UNITED STATES PATENT AND TRADEMARK OFFICE

APPLICATION NO.	FILING DATE	FIRST NAMED INVENTOR	ATTORNEY DOCKET NO.	CONFIRMATION NO.
10/090,473	03/04/2002	David T. Pollock	EDOV-56449	5102

Office Action Summary

Fig. 16 (EDOGA

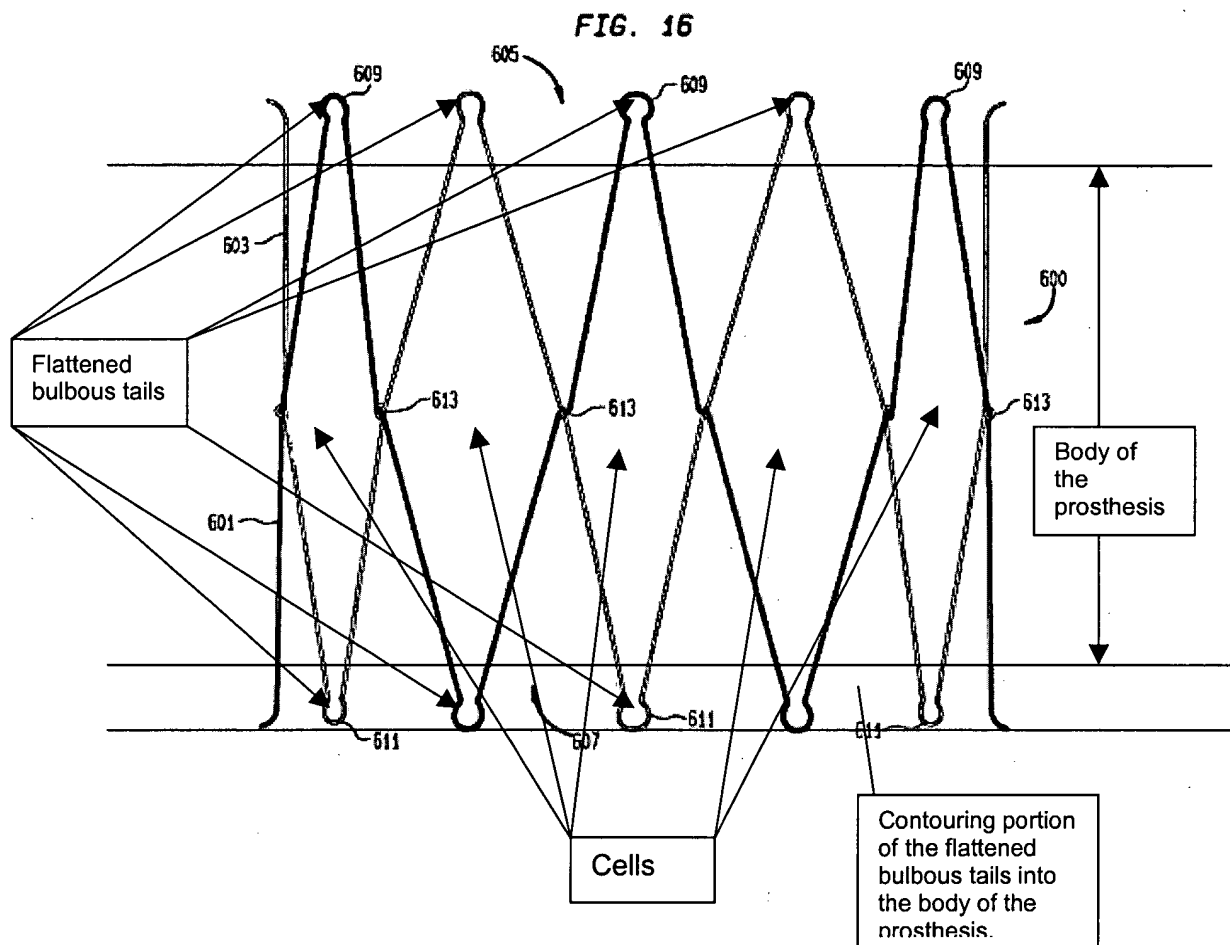
As to claims 16-18 and 23, EDOGA (Fig. 16) discloses a prosthesis/stent 605 having a plurality of cells defined by struts having a first width, flattened bulbous tails 609/611 locate at the top and bottom of the cells. In comparison to Fig. 22B, 22C and specification lines 5-15, page 28 of this application, the adjacent flattened bulbous tails 609/611 of the EDOGA prosthesis/stent 605 are also considered as having a continuous surface that has a second width greater than the first width. Alternatively, it would have been an obvious matter of design choice to modify the width of the flattened bulbous tails 609/611 greater than the first width of the struts, since such a modification would have involved a mere change in the size of a component. A change in size is generally recognized as being within the level of ordinary skill in the art. In re Rose, 105 USPQ 237 (CCPA 1955).

As to claim 19, the flattened bulbous tails 609/611 in Fig. 16 are contouring into the body of the prosthesis 605 as shown in Fig. 16 copied and shown below:

As to claim 20, in comparison to Fig. 22B, 22C and specification lines 5-15, page 28 of this application, the adjacent flattened bulbous tails 609/611 of the EDOGA prosthesis/stent 605 are staggered longitudinally as well.
